Addendum 43 – Regulation No. 44

Revision 3 - Amendment 2

Supplement 9 to the 04 series of amendments – Date of entry into force: 15 June 2015

Uniform provisions concerning the approval of restraining devices for child occupants of power-driven vehicles ("Child Restraint Systems")

"Figures 1a and 1b

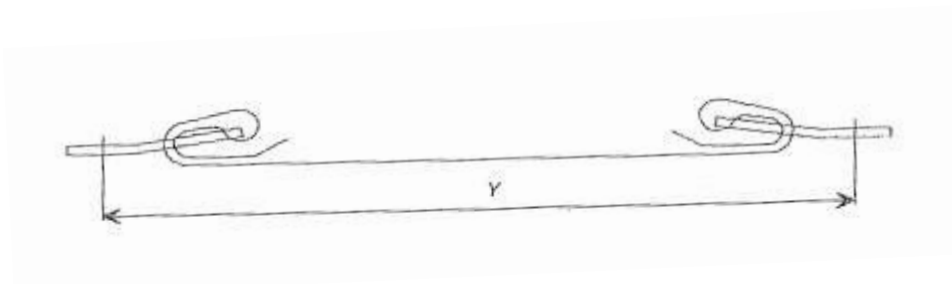
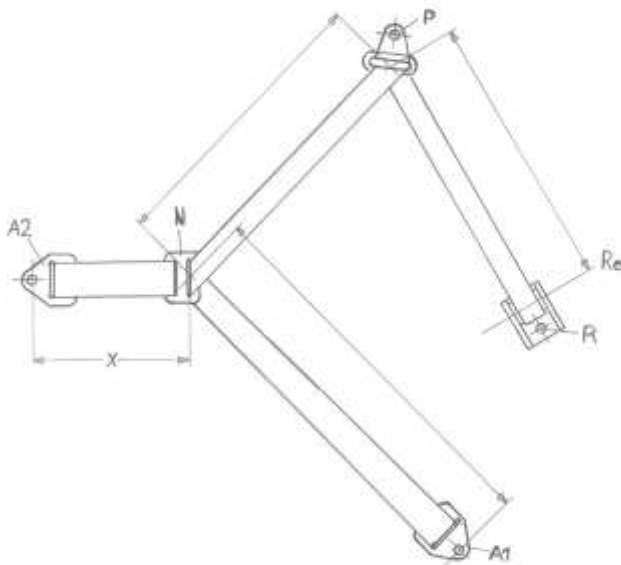
"2. The three-point retracting belt has the following rigid parts: a retractor (R), a pillar loop (P), two anchorage points (A1 and A2) (see Figure 1b)...

The value of X in Figure 1b below..."

"5. The two-point static belt as shown in Figure 1a consists of ...

6. ... The value of Y in Figure 1a is ..."

Figure 1, amend to read:
